Submittal No.: 03c1: Containment Plans, Rev., Pgs. C-1, C-20 & C-21

Description: Proposal/Contract Number: Bradford-Newbury IM BPNT (14)
Letting Date: 10/10/14; Award Date: 11/03/14
Project Description: Bridge Painting of Five Bridges
In the Towns of Bradford & Newbury, VT
Contract Amount: \$4,327,785.00; Completion Date: 08/26/16

SUBMITTAL REVIEW

ABRASIVE BLASTING CONTAINMENT PLANS, REV. 1

SHEET TITLE: CONTAINMENT MISCELLANEOUS DETAILS (2 OF 7)		REF. DWG. NO.
PROJECT NAME: TEN BRIDGES ON OR OVER I-91 IMPROVEMENT PLANS		SHEET NO. C-20

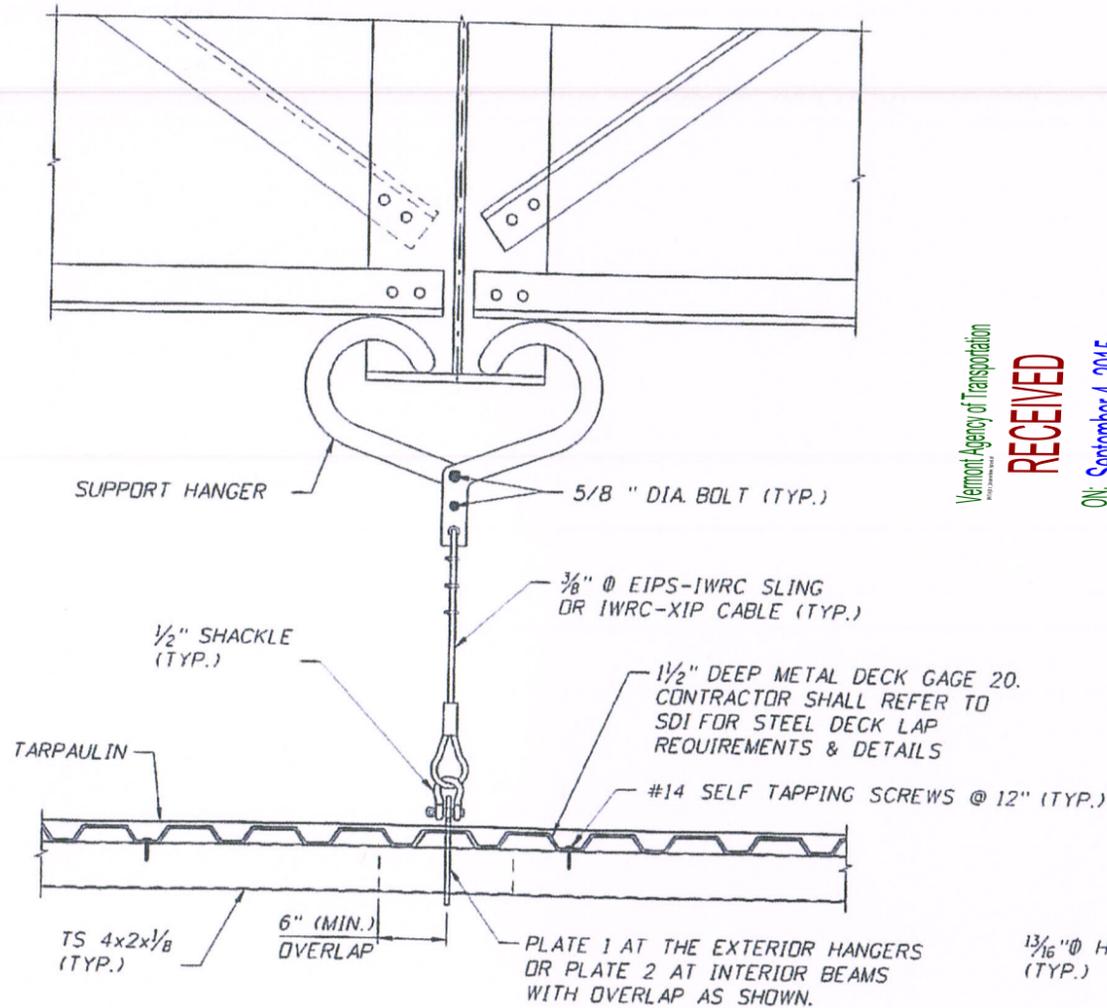
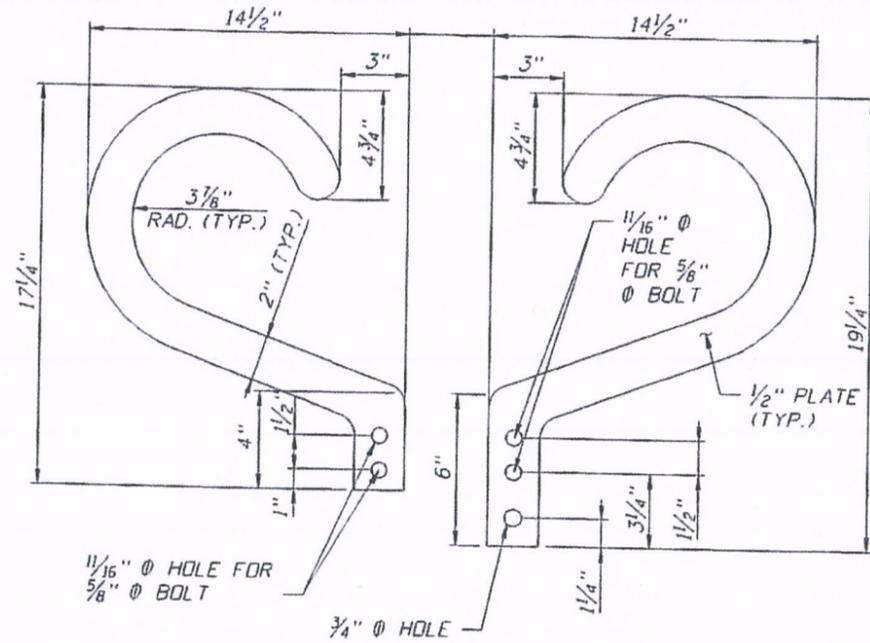
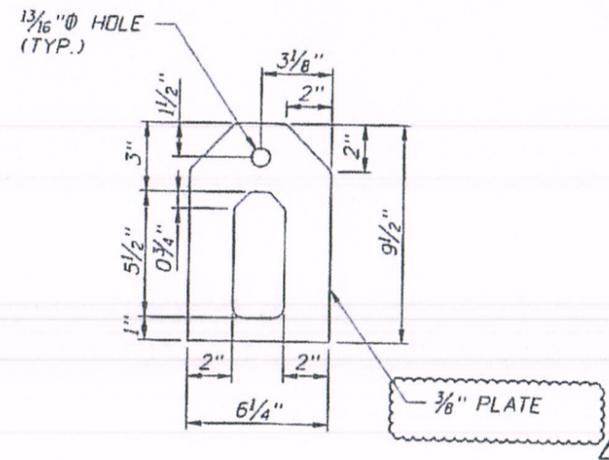
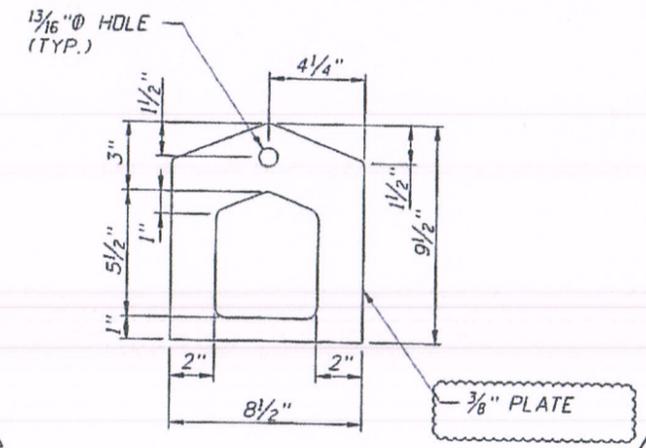
REVISIONS		
DATE	BY	DESCRIPTION
09/02/15	PRS	REVIEW COMMENT

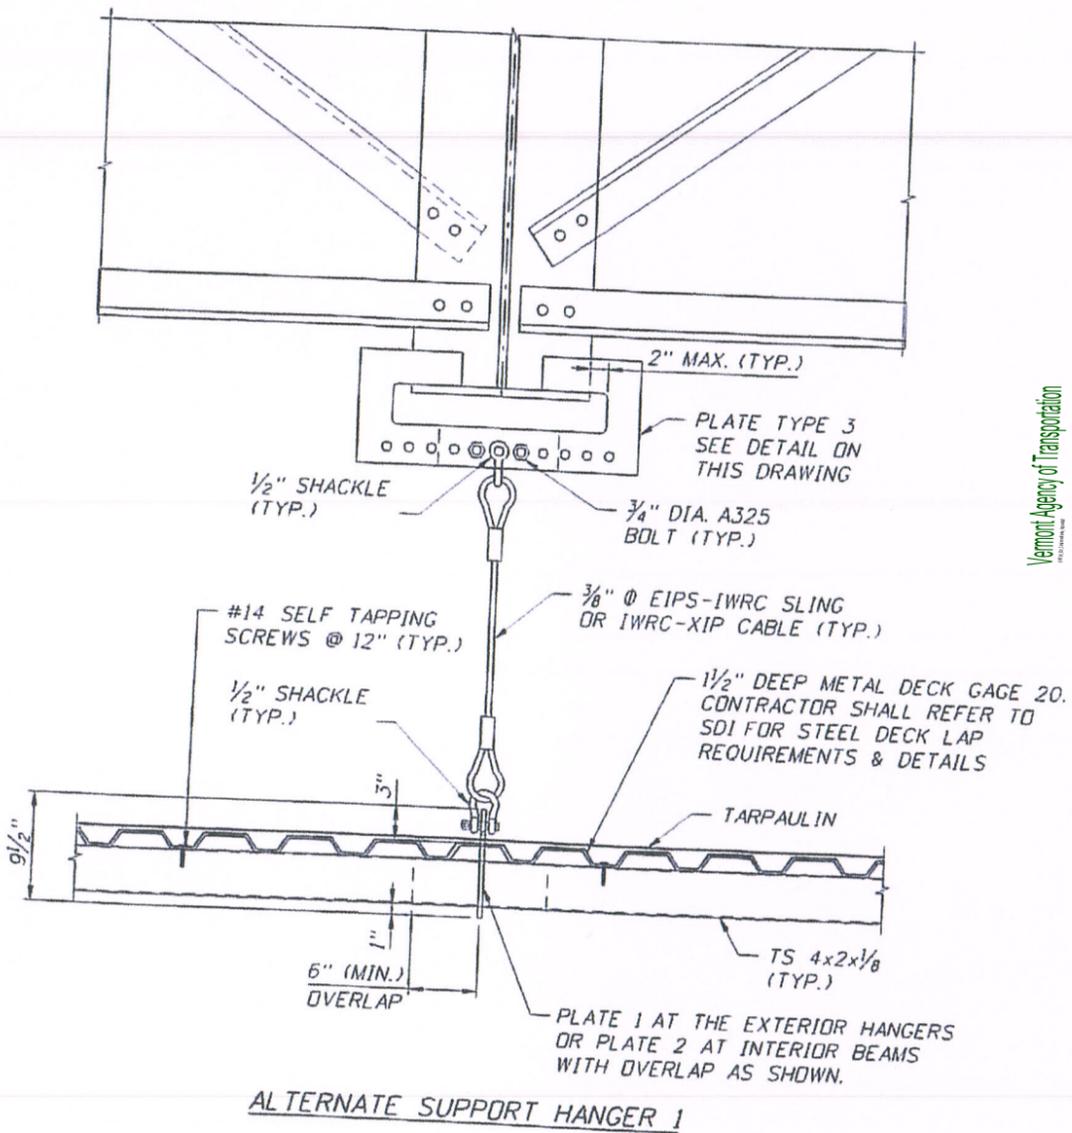
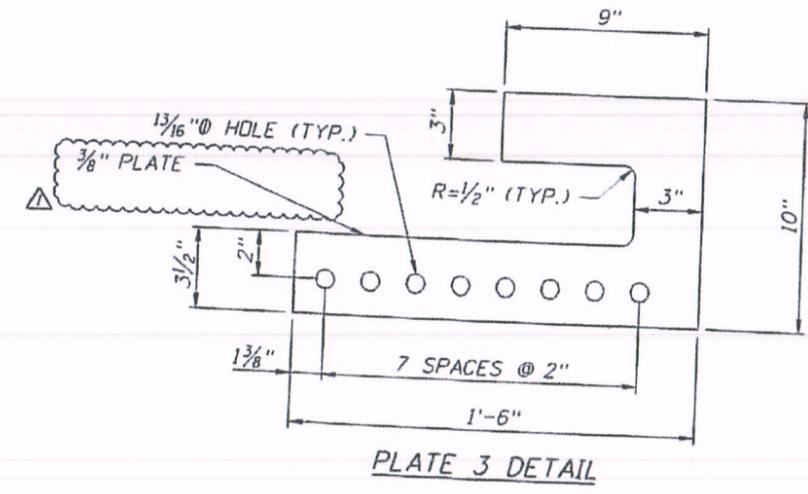
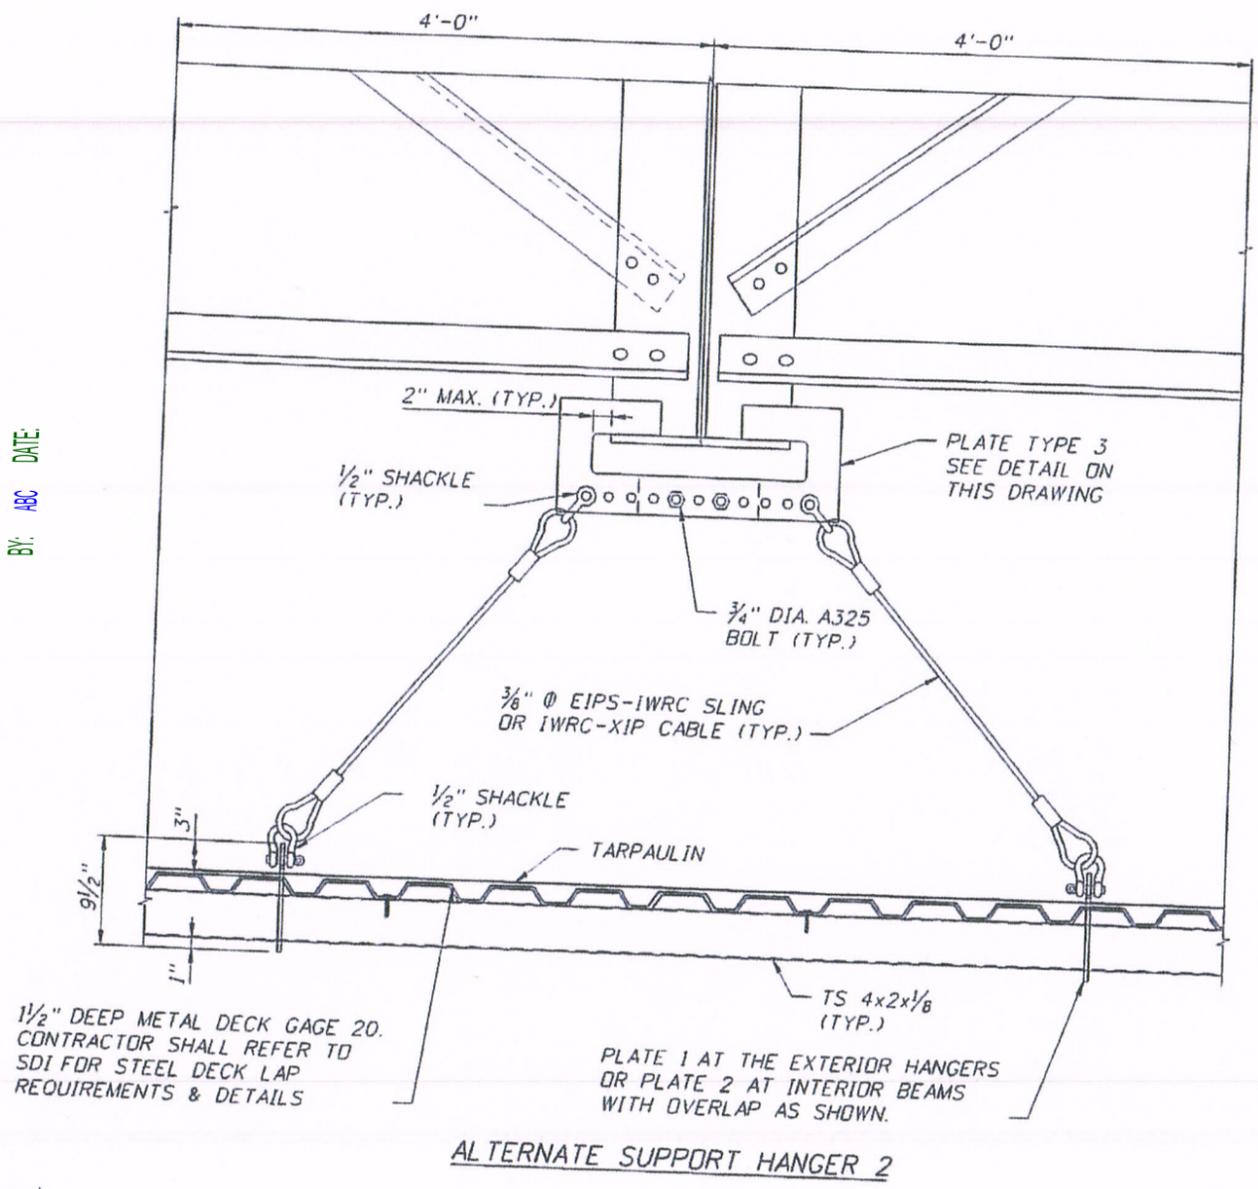
REVISIONS		
DATE	BY	DESCRIPTION
09/02/15	PRS	REVIEW COMMENT
